APPLICATION NO.	FILING DATE	FIRST NAMED INVENTOR	ATTORNEY DOCKET NO.	CONFIRMATION NO.
10/663,259	09/16/2003	Norman S. Martucci	79287.21520	1456
30734 7590 03/23/2007 BAKER & HOSTETLER LLP WASHINGTON SQUARE, SUITE 1100 1050 CONNECTICUT AVE. N.W. WASHINGTON, DC 20036-5304			EXAMINER AFTERGUT, JEFF H	
			ART UNIT	PAPER NUMBER
			1733	
SHORTENED STATUTORY PERIOD OF RESPONSE		MAIL DATE	DELIVERY MODE	
3 MONTHS		03/23/2007	PAPER

Office Action Summary

U.S. Patent Application 10/663,259 filed September 16,
2003; Norman S. Martucci, entitled "Method of Making
Coated Braided Hose Assembly"; Attorney Docket:
79287.21520

NEW INFORMAL DRAWING FIG. 3

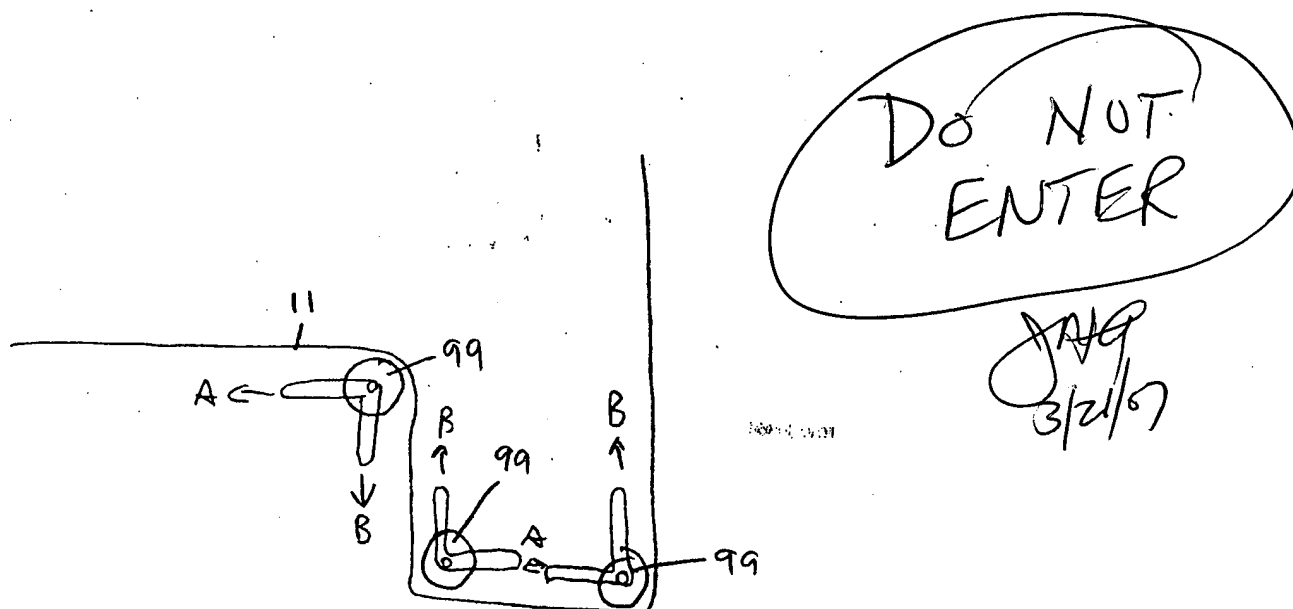
The applicant has presented amended independent claims 1 and 13 for consideration and has added to each of the claims that the "bending devices are adjustable "in at least two directions" and additionally provided a new drawing which is labeled Figure 3 for consideration (to show the adjustability in "at least two directions".

The new drawing appears only to show adjustability in two directions and a very specific manner of arranging the bending devices to allow for adjustability in the horizontal and vertical direction. The applicant is advised that the original disclosure does not support the specific manner in which the bending devices are adjusted as depicted. It should be noted that Figure 3 as provided will not be entered as a new Figure and that Figure 2 should be amended to provide crossing arrows (one arrow in the horizontal plane and another in the vertical plane) adjacent the bending devices in Figure 2 and that the description be altered to state on page 8 that the vertical and horizontal directional adjustments are depicted by the arrows in the Figure. It should be additionally noted that Figure 3 does NOT depict the invention as claimed as the Figure does not provide for more than two directional movement ("at least two directions" infers that there are more than two directions of movement of the bending devices which is not supported by the original disclosure, see below).

5. The proposed new drawing has not been entered, as it appears to add new matter to the disclosure as identifying the specific manner in which the bending devices

are manipulated in the horizontal and vertical directions. It is suggested that Figure 1 be amended by including crossing arrows adjacent or over the bending devices in order to signify that the bending devices can be moved vertically and horizontally in a schematic fashion rather than depicting specific structure for provision of the same. Applicant is additionally advised in this regard that the reference to Figure 3 in the amendment dated
